Technical memorandum for an application for subdivision consent under the Resource Management Act 1991 in respect of 42 Okura Road, Elsthorpe

From: Lee Paterson, Senior Geotechnical Engineer, Stantec

Application number: RM230016

3. Overview and scope of technical memorandum

completed over four stages. An excerpt of the proposed scheme plan is included in **Figure 1** below.

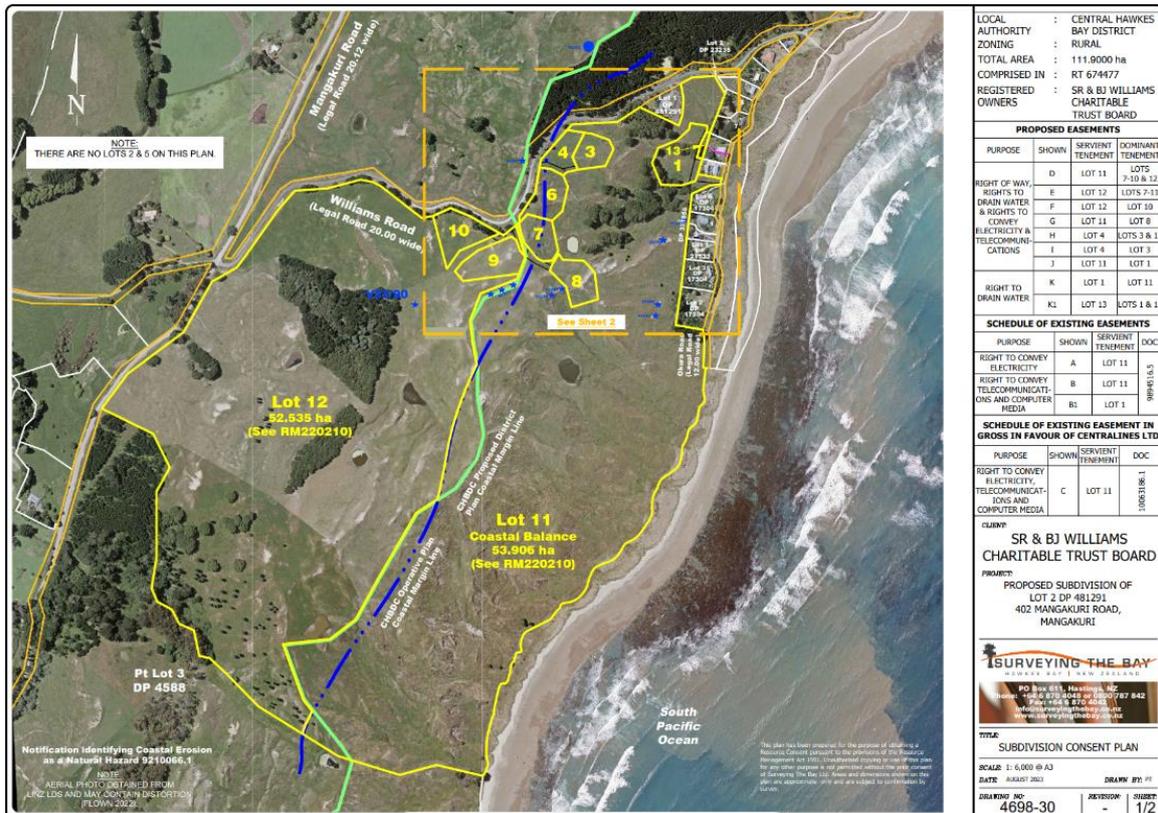
- 11.4. Plans should show "no build" zones to inform setbacks in survey set-out terms, rather than potentially ambiguous relationships to breakover slope angles.
- 11.5. Excavations are proposed to lower some sites to a level in order to achieve suitable factors of safety. This level should be explicitly defined in the conditions.
